4A COMMUNICATION SYSTEM

(“COM KEY®” 416)

IDENTIFICATION, INSTALLATION, CONNECTION, OPERATION, AND MAINTENANCE CUSTOMER EQUIPMENT

1.001 This addendum supplements Section 518-450-106, Issue 3. Place this pink sheet ahead of Page 1 of the section.

Fig. 9A—Typical Arrangement of Coupled Bonding Conductor

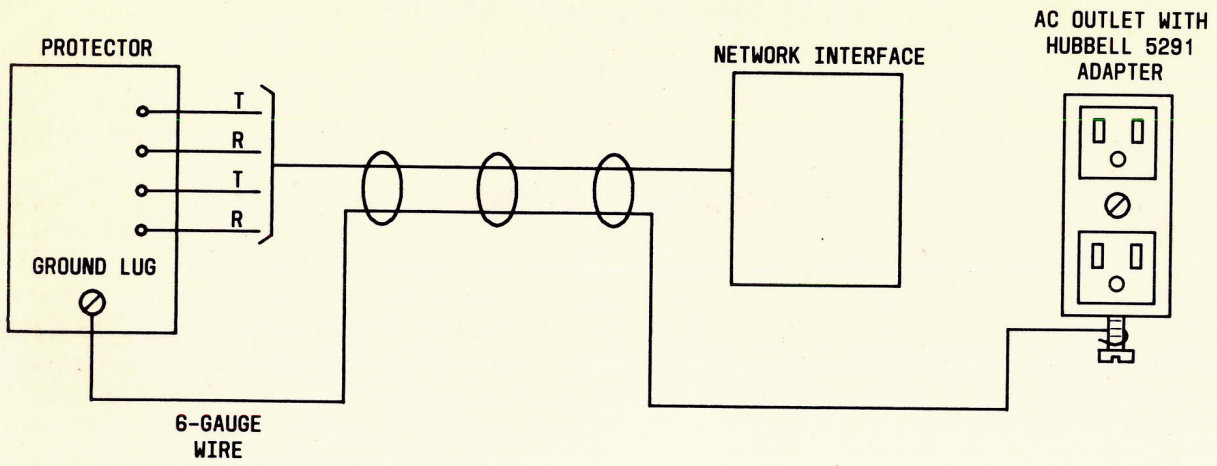
- Put Section 518-450-106 in compliance with the Federal Communications Commission (FCC) ruling which requires that a warning statement be placed in the users documentation for equipment that generates and uses radio frequency energy and may radiate this energy
- Prohibit the use of the 91A connecting block (MD) in all new installations
- Specify size of wire to be used for coupled bonding conductor
- Add Fig. 9A showing method of connecting coupled bonding conductor
- Correct minor typographical errors.

- 2.006 In paragraph 3.10 on Page 21, add “(Fig. 9A)” at end of first sentence.
- 2.007 On Page 36, change the heading of paragraph 3.43(a) from “Early Model or 109A Loudspeaker” to “Early Model of 109A Loudspeaker”
